We express our gratitude to the editor and the anonymous reviewers for their valuable feedback and for giving us the chance to revise and thereby improve our manuscript entitled: "Validation and field application of a low-cost device to measure CO₂ and ET fluxes." We have thoroughly addressed each comment from the reviewers in a detailed manner. Please take note of the color coding in our responses: (I.) reviewer comments are displayed in black; (II.) our responses are indicated in green; (III.) parts of the manuscript containing modifications are presented in italic and grey.

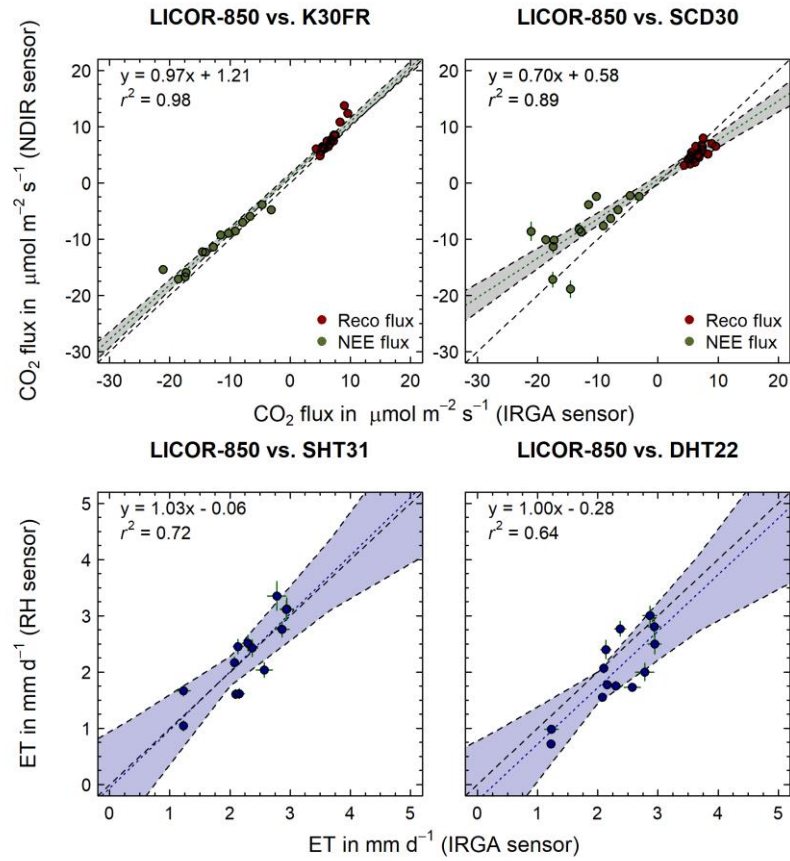
-In section 2.5.3. the author says that Error calculation for CO₂ and ET fluxes were quantified using a comprehensive error prediction algorithm described in detail by Hoffmann et al (2015). However, the reader would appreciate an understandable error analysis. For example, in figures 6 and 7 you say "error bars indicate calculated flux error ($\alpha = 0.9$). What does this α means? The only α I know in statistics is the *level of significance*, and is never higher than 0.05.

Figure 6: As in the text you talk about Reco and NEE fluxes, you could differentiate it by using different colours or point shapes.

We appreciate the valuable comment on figures 6 and 7. We indeed accidentally mixed α with the confidence interval (CI) aimed to be reported here. To furthermore make the error analysis more understandable, we changed the reporting format in figure 6 and 7 captions, now including the CI and p -value as follows: (CI: 95%; $p < 0.05$).

To do so we recalculated and applied in the corresponding figures the given errors for a 95% CI instead of the initially used 90% CI given in figure 6 and 7. However, we also want to emphasize that depending on the discipline and kind of measurements, the level of significance can be indeed higher than $\alpha = 0.05$ (e.g. $\alpha = 0.1$) (Bonnet et al., 2021; Prado-Lorenzo et al., 2009; Friedl and Getzner, 2003)

R_{eco} and NEE fluxes in Figure 6 are now differentiated using different colors.
